**SUPPORTING INFORMATION FOR THE STRESS
ANALYSIS OF THE THIN PIPE REGION IN THE
NO. 12 STEAM GENERATOR MAIN STEAM LINE
(EB-01-1005-05)**

FINAL REPORT
SwRI Project No. 06-1917-203

Prepared For
Baltimore Gas and Electric
Charles Center
P. O. Box 1475
Baltimore, Maryland 21203

March 1988

FIGURE 3.2
REPORTED PIPE STRESS LOCATIONS
IN PLANE OF THIN PIPE REGION

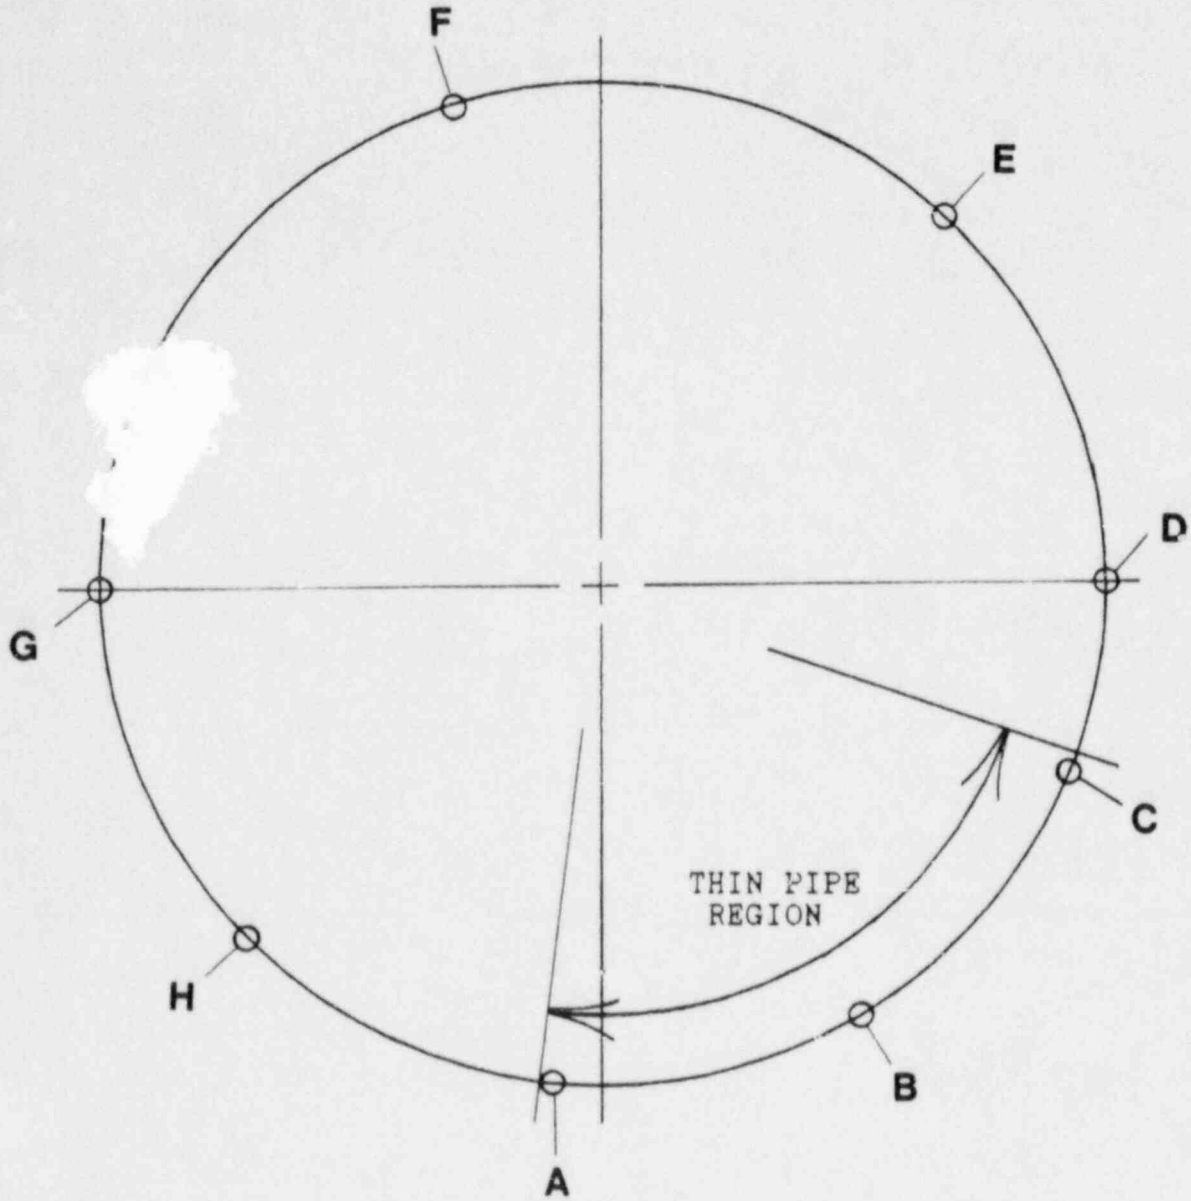
- 1.) A description of the shell elements used in the finite element analysis of the thin pipe region and elbow,
- 2.) The state of stress in the pipe 180 degrees away from the thin pipe region, and
- 3.) Complete information about the pipe beam model used to determine the deadweight forces and moments which were used in the detailed analysis of the thin pipe region.

The location of the thin pipe region is shown diagrammatically in Figure 3.1. This is the same figure as Figure 1 in the original report. Table 3.1 presents the hoop and longitudinal stress components in the plane of the thin pipe at the locations indicated in Figure 3.2. Outside, mid, and inside surface stress components are reported in the table. The loading condition which produced these stress levels was a combination of an internal pressure of 1000 psig and deadweight.

LOCATION (NOTE 1)	STRESS COMPONENT	STRESSES (PSI)		
		OUTSIDE SURFACE (NOTE 2)	MID SURFACE (NOTE 3)	INSIDE SURFACE (NOTE 2)
A	HOOP	11,600	14,900	18,100
	LONGITUDINAL	7,400	8,700	11,400
B	HOOP	14,200	14,600	15,000
	LONGITUDINAL	6,700	7,900	9,200
C	HOOP	11,400	15,900	19,600
	LONGITUDINAL	6,100	8,400	10,700
D	HOOP	16,600	15,000	13,400
	LONGITUDINAL	7,900	7,600	7,400
E	HOOP	15,500	15,700	15,800
	LONGITUDINAL	7,700	7,600	7,600
F	HOOP	16,900	15,700	14,600
	LONGITUDINAL	7,100	6,600	6,100
G	HOOP	13,500	15,000	16,400
	LONGITUDINAL	6,700	7,400	8,100
H	HOOP	14,300	14,200	14,000
	LONGITUDINAL	6,700	7,500	8,300
